7/21/21	<span style="color:red">6</span> Added Removal of Existing Delineators
7/14/21	<span style="color:red">4</span> Added Clear & Grub Limits
DATE	REVISION
STATE OF HAWAII DEPARTMENT OF TRANSPORTATION HIGHWAYS DIVISION	
<b>DEMOLITION AND EROSION CONTROL</b>	
<b>INTERSTATE ROUTE H-1 RESURFACING</b>	
Miller Pedestrian Overpass to Kapiolani Interchange	
Federal-Aid Project No. NH-HI-1(279)	
Scale: 1" = 40'	
Date: August 2021	
SHEET No. EC4 OF 23 SHEETS

<b>DEMOLITION AND EROSION CONTROL</b>	
INTERSTATE ROUTE H-1 RESURFACING	
Miller Pedestrian Overpass to Kapiolani Interchange	
Federal-Aid Project No. NH-HI-1(279)	
Scale: 1" = 40'	
Date: August 2021	
SIGNATURE	04/30/22
EXPIRATION DATE OF THE LICENSE	
SHEET No. EC7 OF 23 SHEETS

DEMOLITION AND EROSION CONTROL	
<u>INTERSTATE ROUTE H-1 RESURFACING</u>	
<u>Miller Pedestrian Overpass to Kapiolani Interchange</u>	
Federal-Aid Project No. NH-HI-1(279)	Date: August 2021
Scale: 1" = 40'	
SHEET No. EC8 OF 23 SHEETS

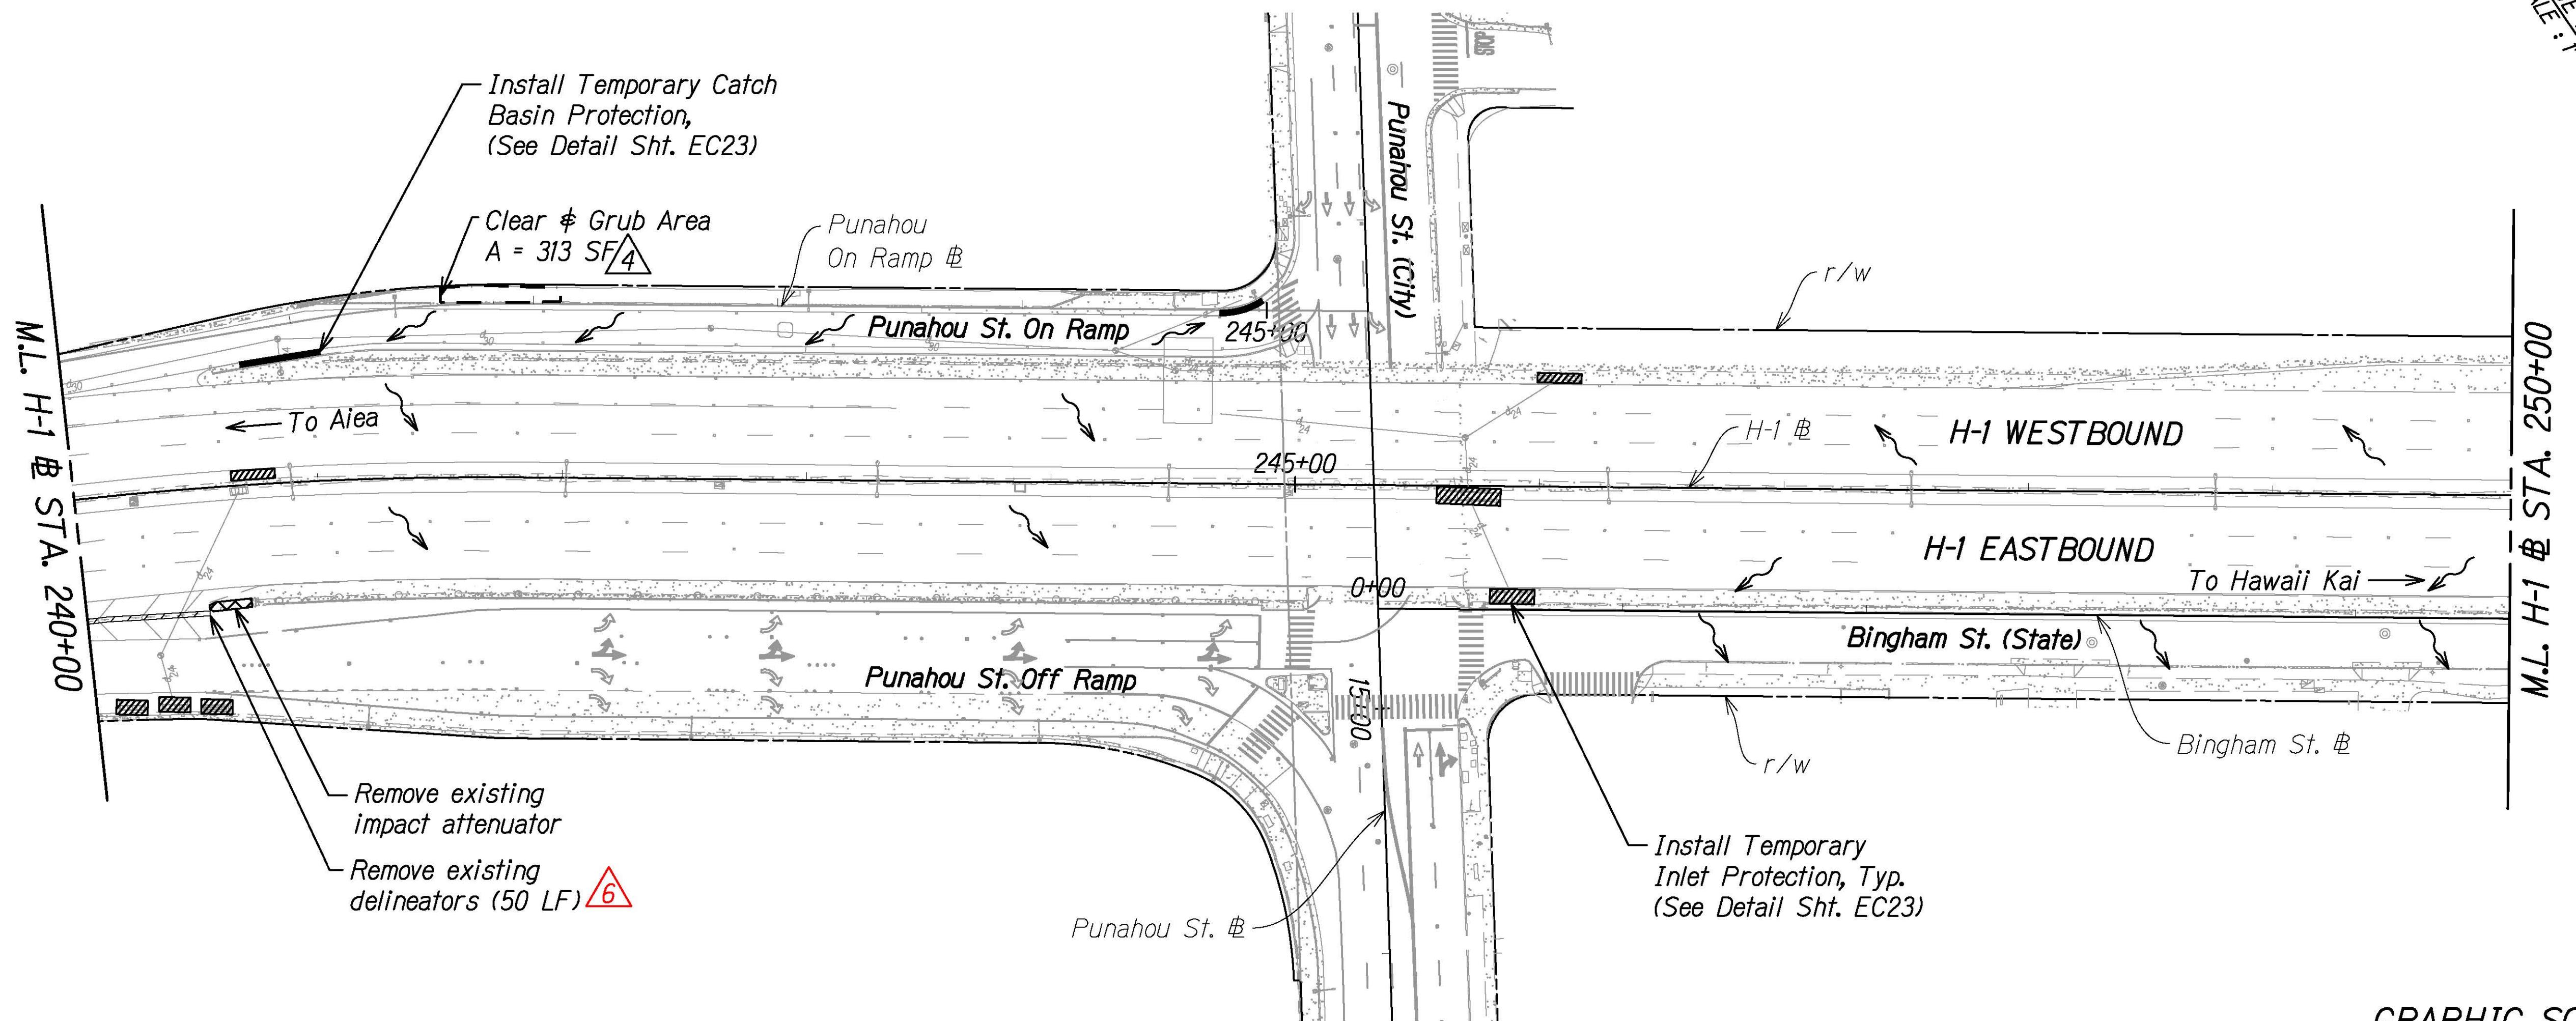
7/21/21	⑥ Added Removal of Existing Delineators
7/14/21	④ Added Clear & Grub Limits
DATE	REVISION

SHEET No. EC13 OF 23 SHEETS

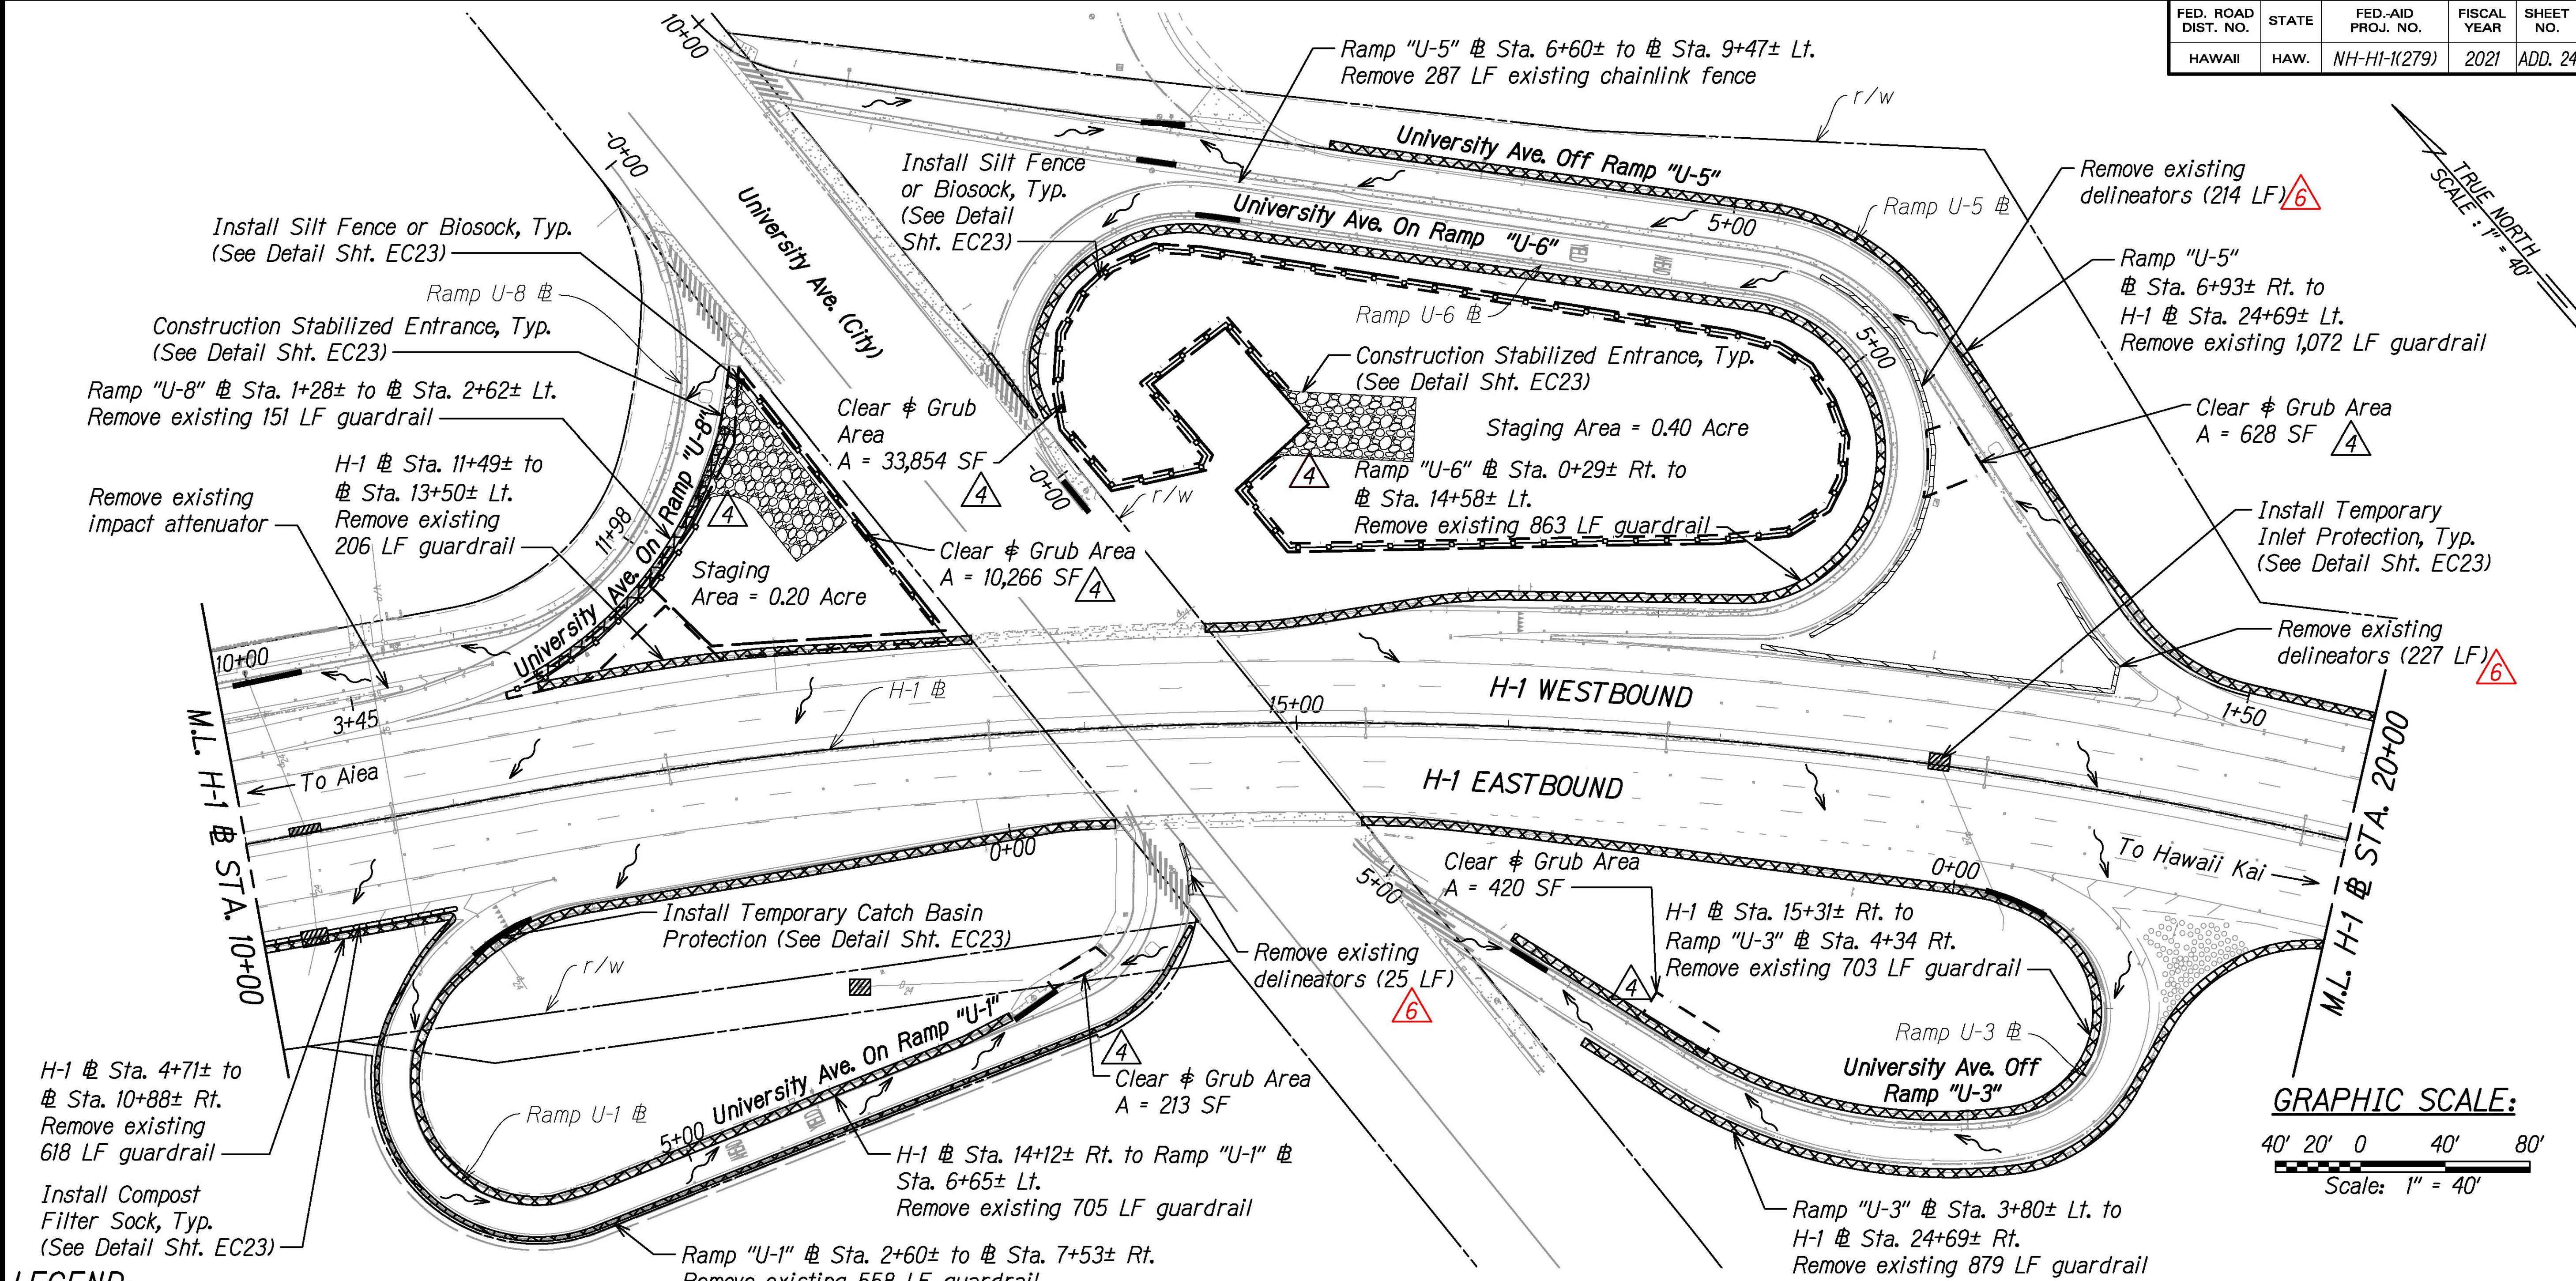
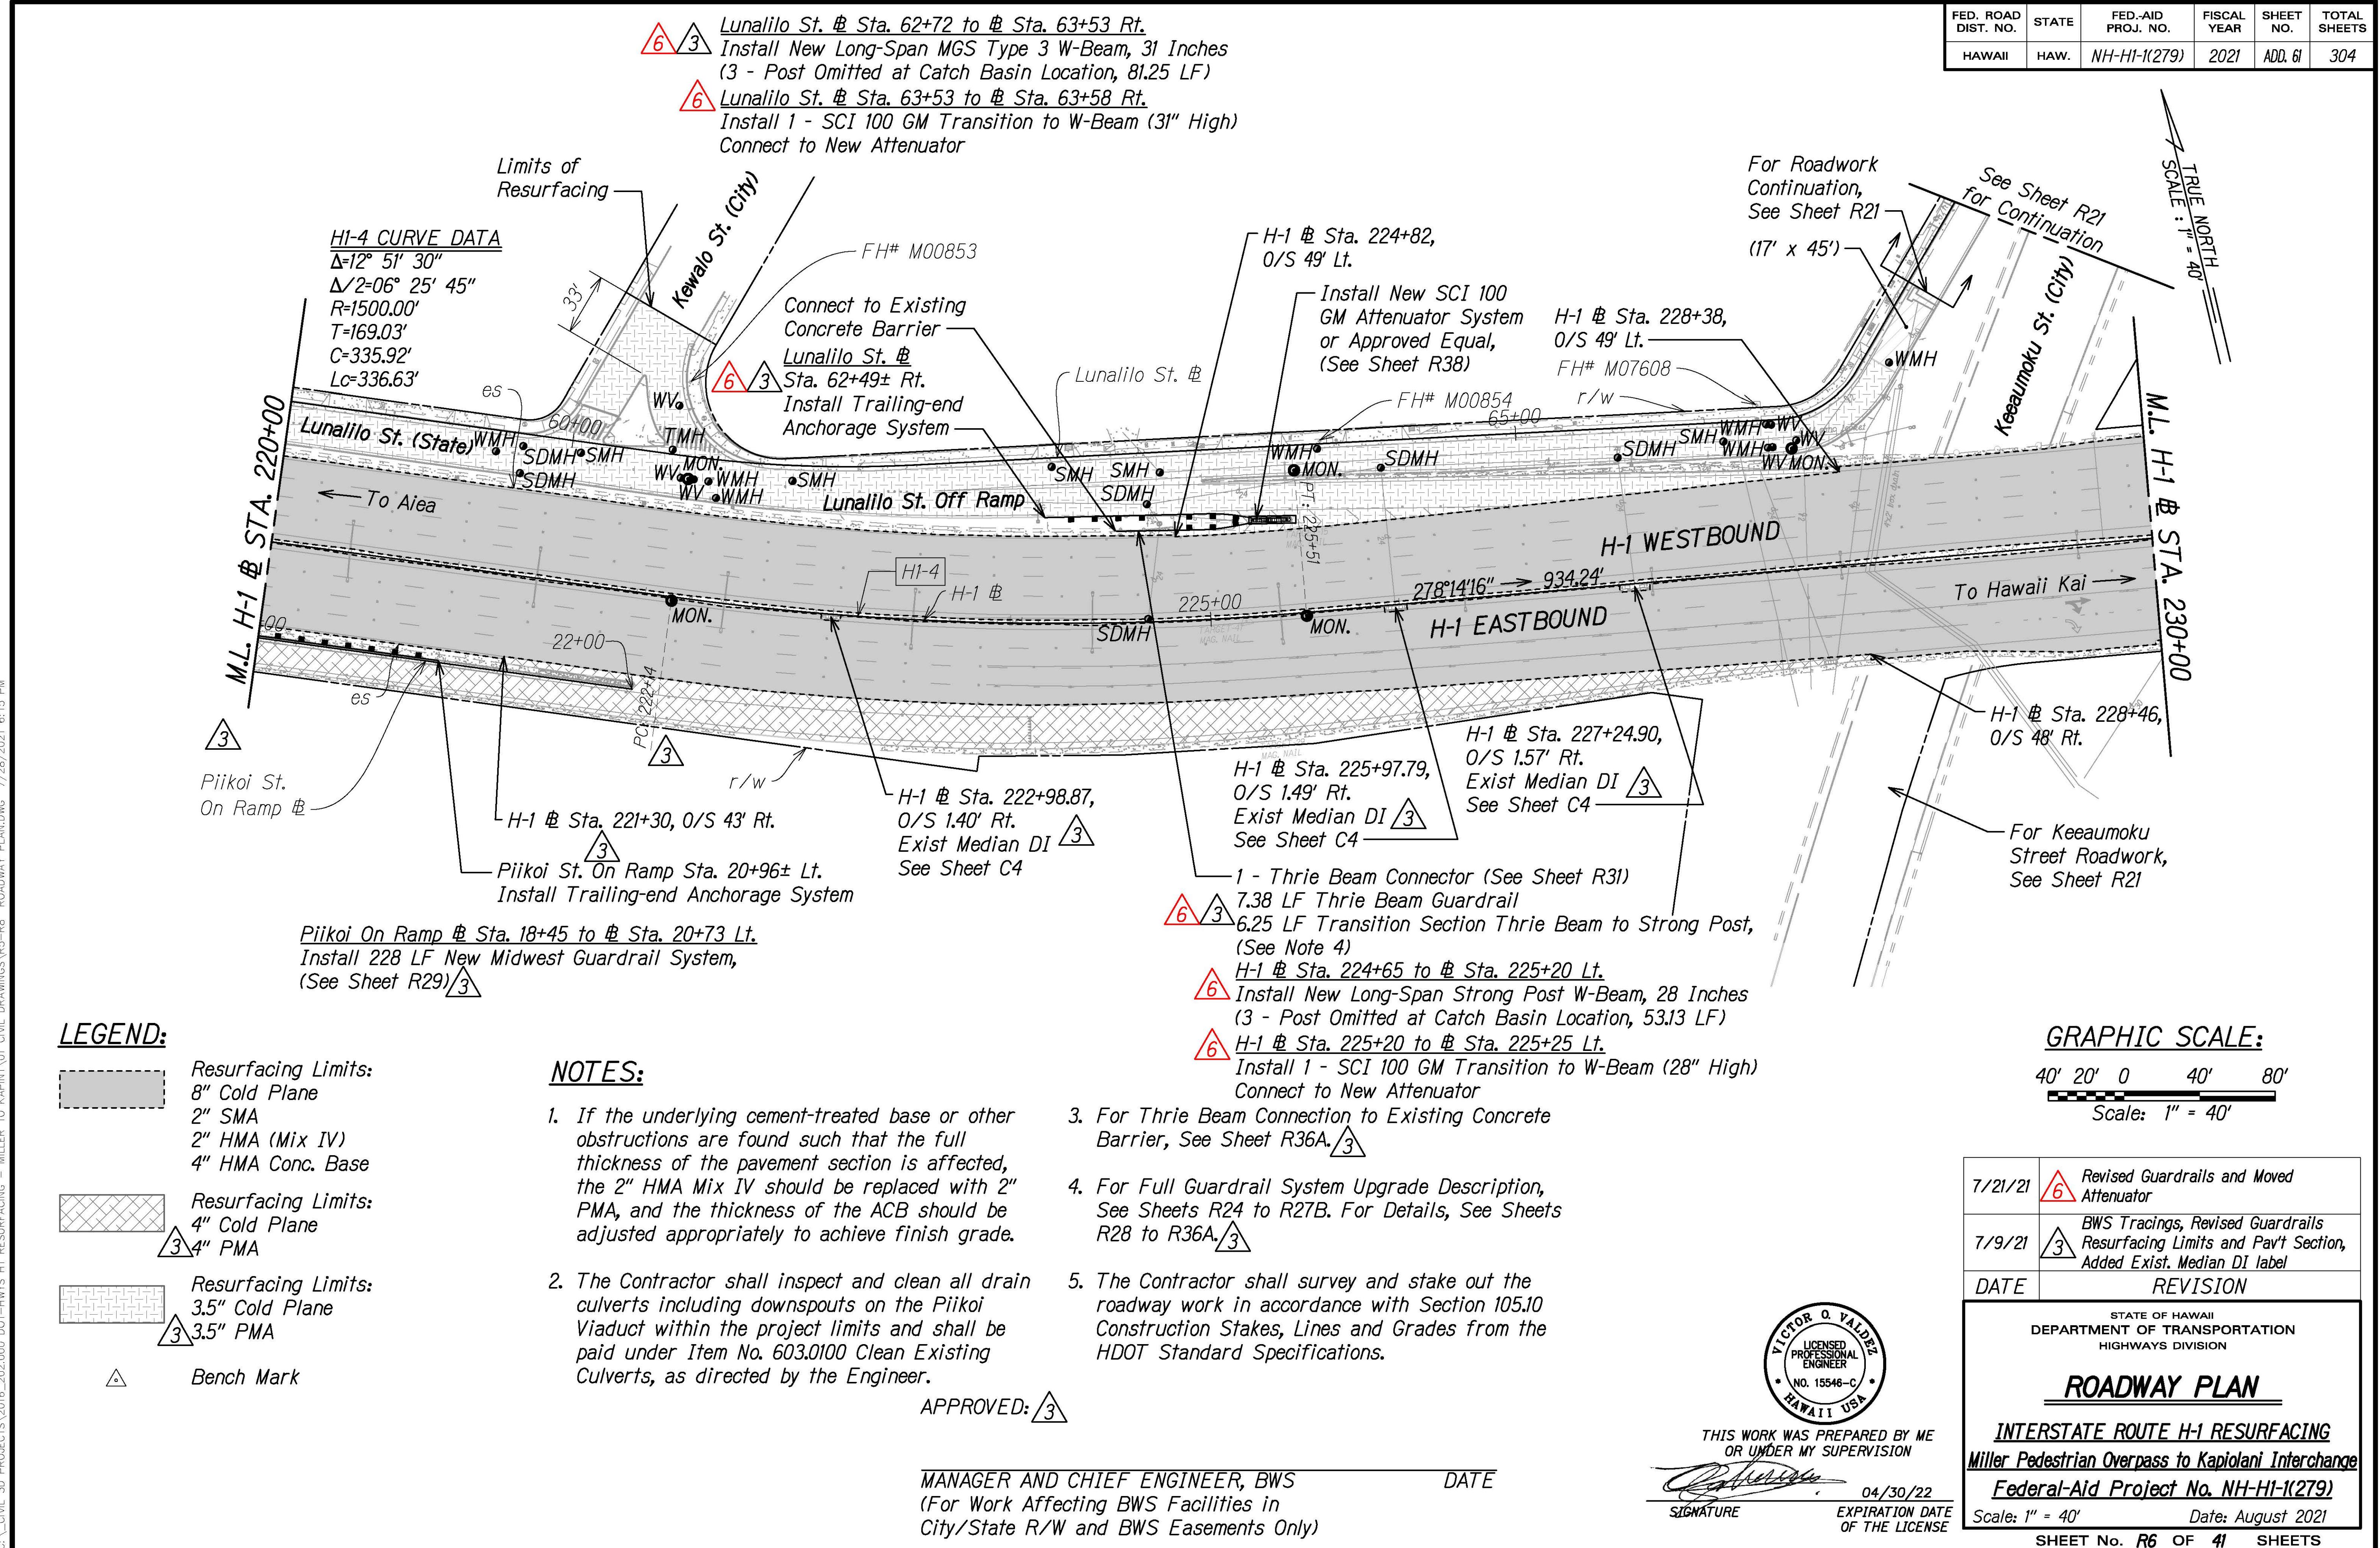
Clear & Grub Area  
A = 628 SF △6

Remove existing delineators (227 LF) △6

7/21/21	Added Removal of Existing Delineators <span style="color:red;">△6</span>
7/14/21	Added Clear & Grub Limits, Revised Construction Entrances & Silt Fence <span style="color:red;">△4</span>
